**REQUEST**

Current Zoning: N1-A (neighborhood 1, A)  
Proposed Zoning: N1-F(CD) (neighborhood 1, F, conditional)

**SUMMARY OF PETITION**

The petition proposes to develop two triplex buildings and one quadplex on two parcels currently developed with two single family detached homes.

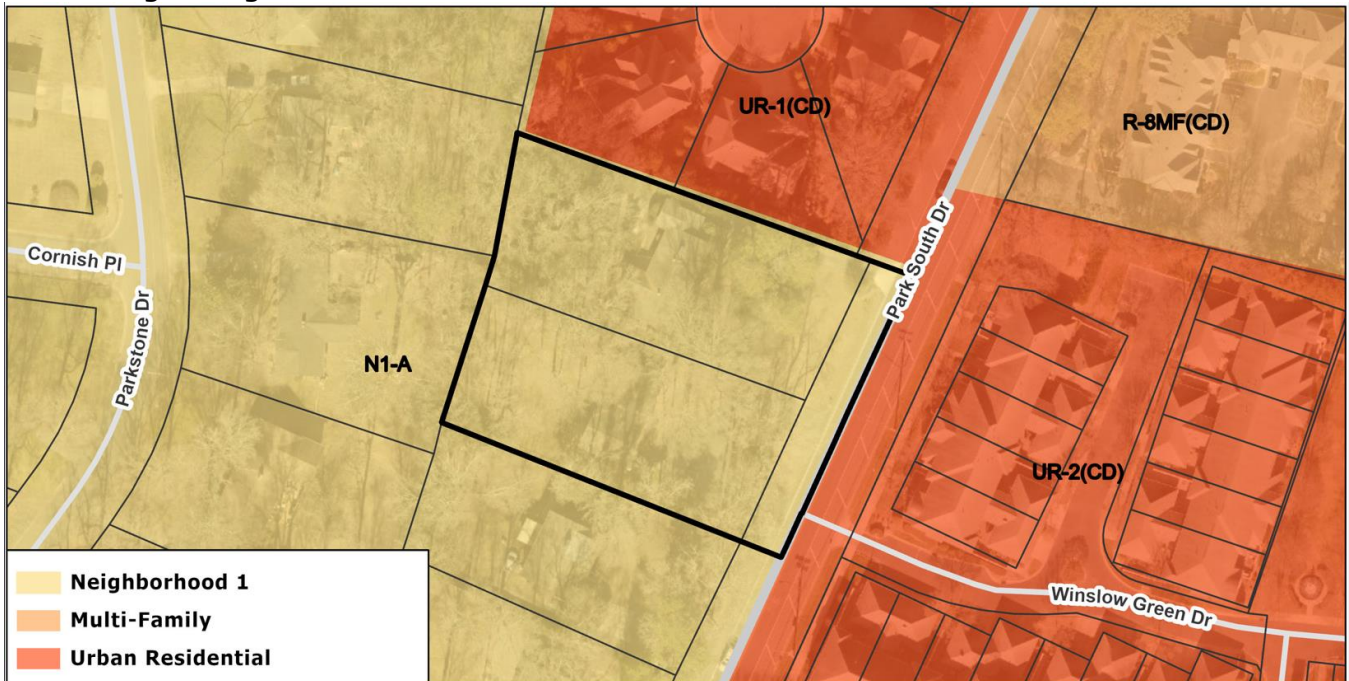
1. Revise the proposed driveways for the individual units to be compliant with Article 19.6.A.1.a of the UDO.

2. Clarify if the tree save area shown on the site plan is outside of the demolition plan.

3. The dimension for the proposed back of curb to the center line must be shown on the site plan as well as the buffered bike lane that is required per the Charlotte Streets Map cross section.
